Magnaloy Coupling Company

Technical Product Information

Pump/Motor Mounts

M056 Service Window Cover

Old Service Window Cover
Part # M056-1

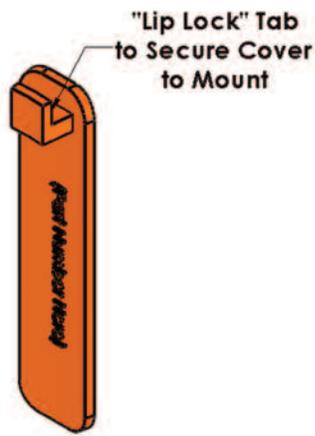
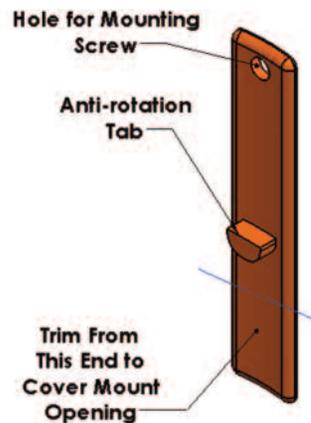
The M056 Group Size Pump/Motor Mounts have not INCLUDED a Service Window Cover as a standard item. This cover, for those who wanted one, had to be ordered as a separate item (Part Number M056-1). When the supply of these covers was exhausted, it was decided to redesign the cover and make it a **standard** item when the M056 Group Size Mount was ordered. When the current inventory supply of packaged M056 Mounts is exhausted, the new inventory will include this cover. In the mean time, customers ordering the M056 Group Size Mount who wish to have a cover, will still have to order it as a separate item (Part Number M056-2) and this bulletin will explain the installation procedure for the new cover. The previous cover had a "lip lock" design where the cover clipped over the casting at the window opening. The "lip lock" design held the cover on the mount.

The New Cover does not have this "lip lock" feature and has a tab in place of it that will fit in the window opening to prevent the cover from rotating. At the opposite end, there is a hole for a 1/4-20 self tapping mounting screw. The cover will have to be cut to the required length for the mount being used and the mount will have to be drilled with a #1 drill per the illustration below.

Customers ordering this cover prior to our inventory turn over, will have to perform this installation process. After the inventory turn over, all mounts will come with the cover pre-installed.
